Access Compliance Report

Public Rights-of-Way

Intersection ID: 30206	Main Street: COY_CT	Cross Street: PATRICIA_RYAN_DR	Location: W
ADA ID: 719FACD48B97	Ramp Type: Perp	Initial Pass/Fail: Fail	Overall Compliance: No
		Severity Score: 8.75

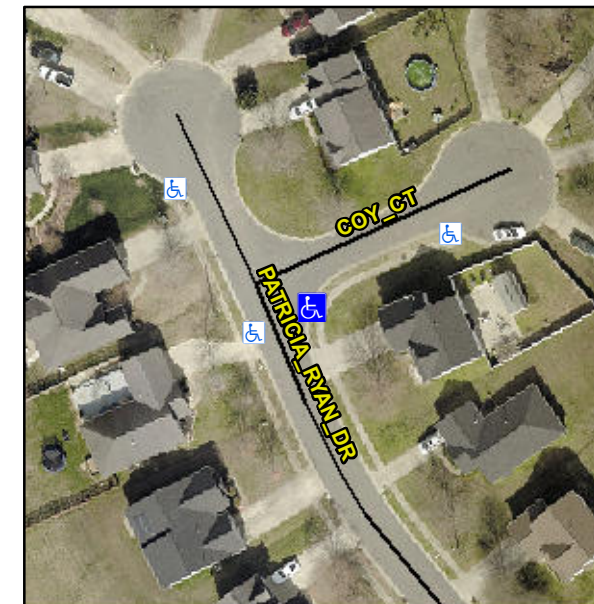
R304.5.1

Compliance	Description	Data	Compliance	Description	Data
N/A	Ramp Length (in)	46.0	Yes	Ramp Slope (%)	5.9
No	Ramp Width (in)	45.0	Yes	Ramp XSlope (%)	1.9
N/A	Flare Type LT	N/A	N/A	Flare Type RT	N/A
N/A	Flare Slope LT (%)	N/A	N/A	Flare Slope RT (%)	N/A
N/A	Flare Traversable LT?	N/A	N/A	Flare Traversable RT?	N/A
N/A	Landing Length (in)	N/A	N/A	DWS Provided?	N/A
N/A	Landing Width (in)	N/A	N/A	DWS Contrast?	N/A
N/A	Landing Slope (%)	N/A	N/A	DWS Length (in)	N/A
N/A	Landing X Slope (%)	N/A	N/A	DWS Full Width?	N/A
N/A	Landing Curb? (Y/N)	N/A	N/A	DWS Offset (in)	N/A
N/A	Shared Landing?	N/A			
N/A	Gutter Ponding?	N/A	N/A	Gutter Slope (%)	N/A
N/A	Gutter Lip Ht (in)	N/A	N/A	Gutter X Slope (%)	N/A
N/A	Painted X Walk1?	No	N/A	Painted X Walk2?	N/A
	X Walk 1 Direction	To N		X Walk 2 Direction	N/A
N/A	X Walk 1 Width (in)	N/A	N/A	X Walk 2 Width (in)	N/A
	X Walk 1 Slope (%)	2.9		X Walk 2 Slope (%)	N/A
	X Walk 1 X Slope (%)	0.7		X Walk 2 X Slope (%)	N/A

Remove & Replace Entire Ramp.
